Minutes of 49th meeting of the Expert Group on Zoo Designing of CZA held on 12th March, 2014 in the office of the Central Zoo Authority

6. VJB Udyan Zoo, Byculla, Mumbai

4. Aviary:

GROUND FLOOR LAYOUT 1:200
 BIRD'S AVIARY-01

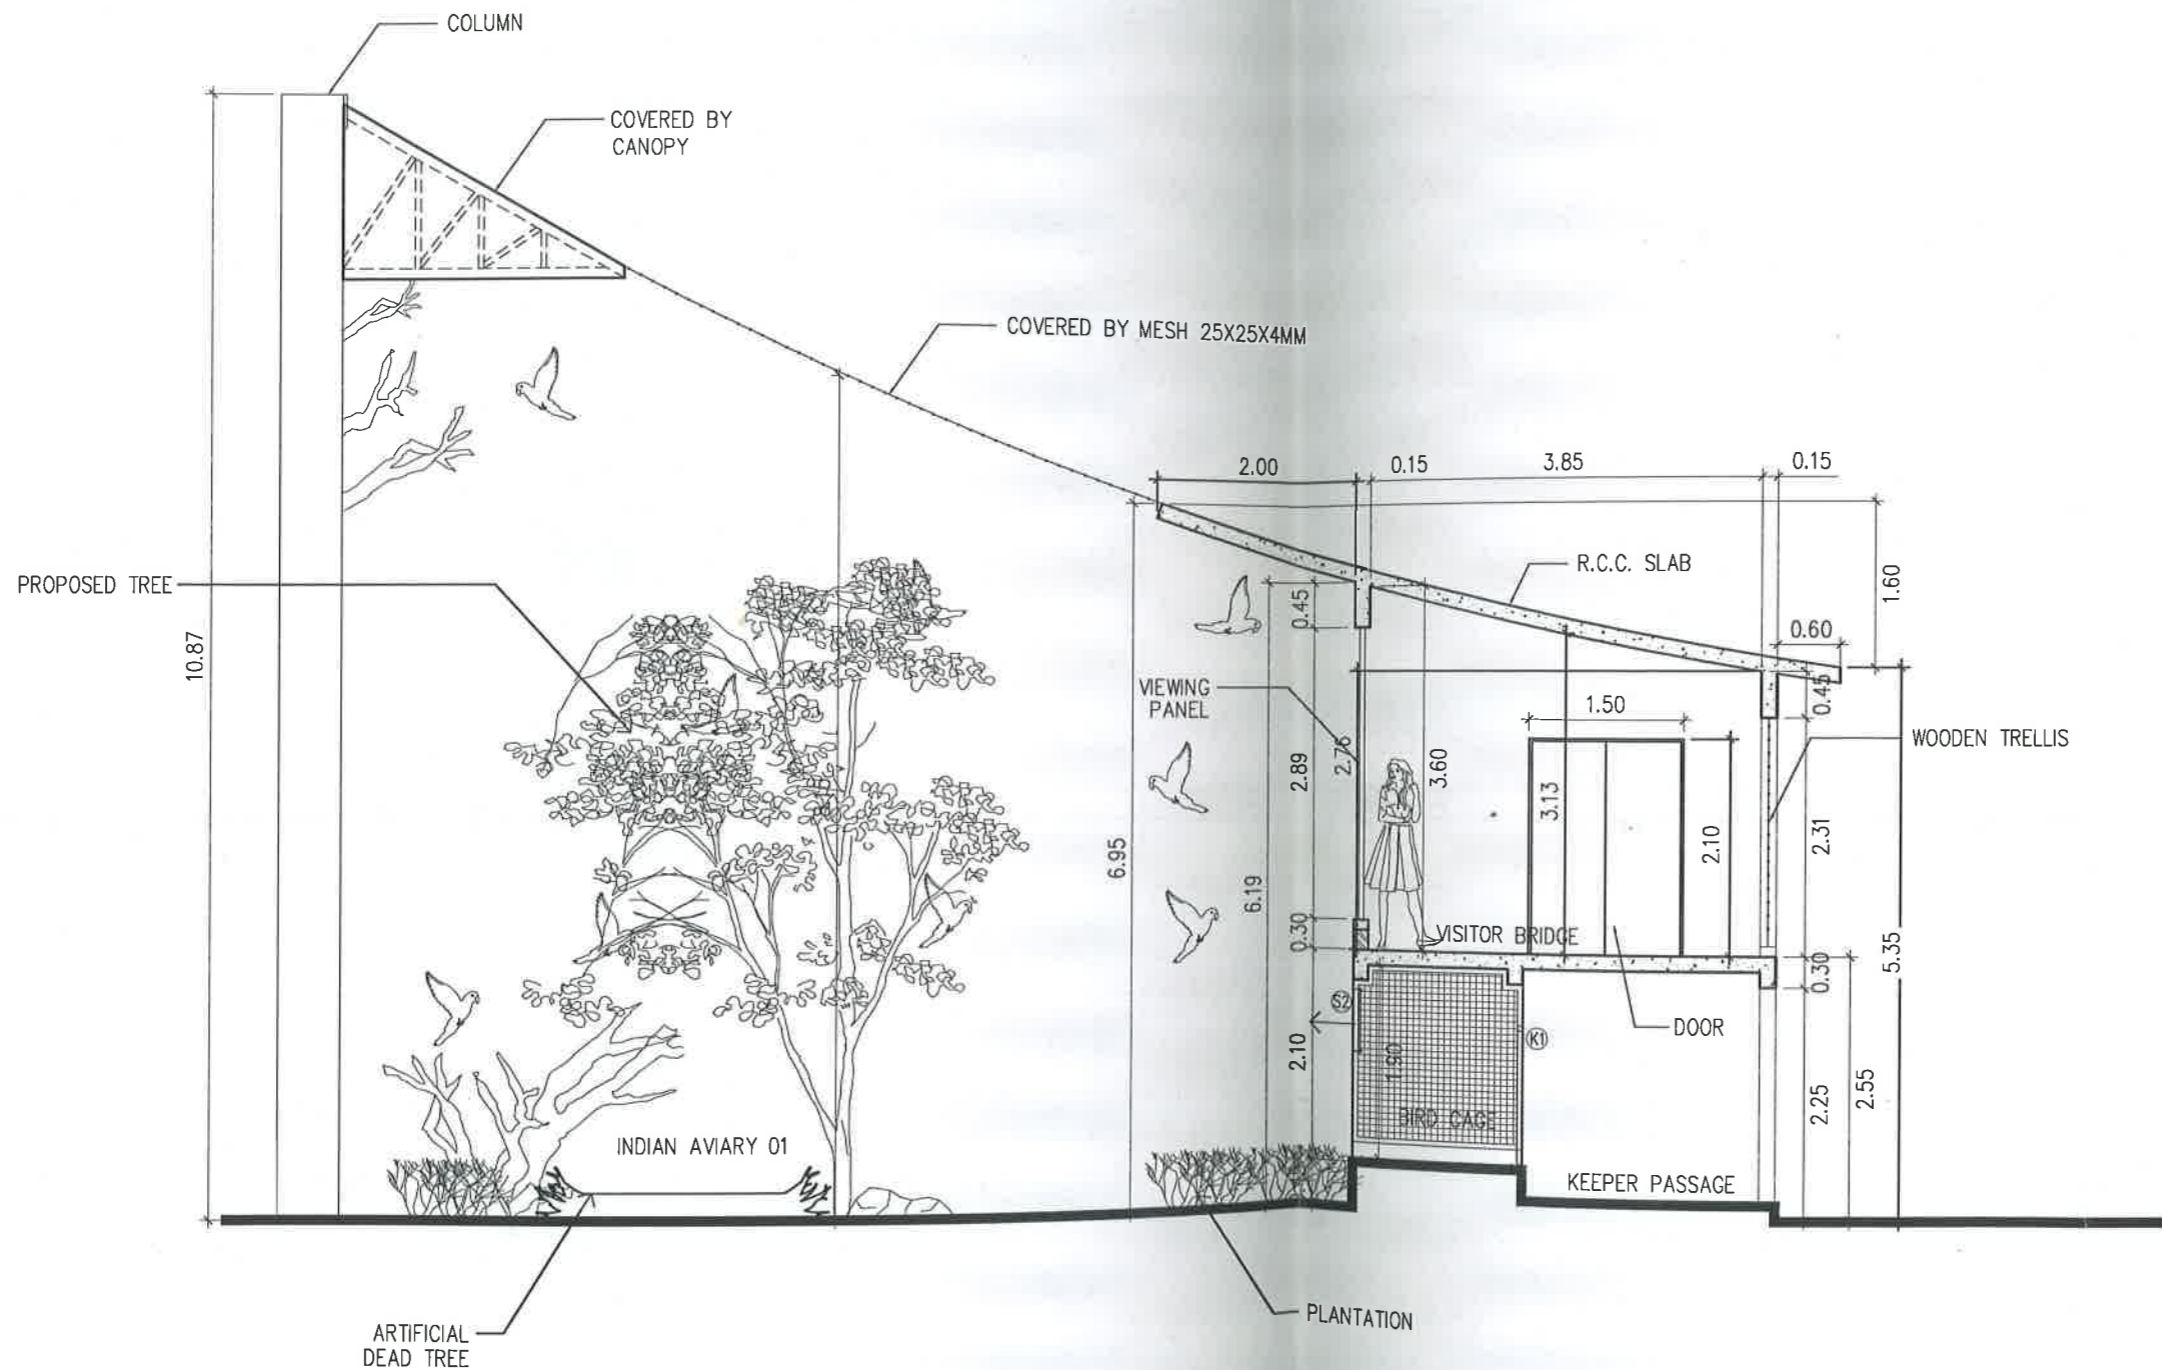
1. The proposed aviary should be made more aesthetic.
2. The shape of the aviary should be made round.
3. All vegetation in the area of aviary and adjoining areas should be protected and not disturbed.
4. The zoo should not make solid concrete walls anywhere; instead board walk with environmental friendly material should be used.
5. The zoo authorities should make a 3-D model using clay or any other material for the appreciation by the visitors and locals.
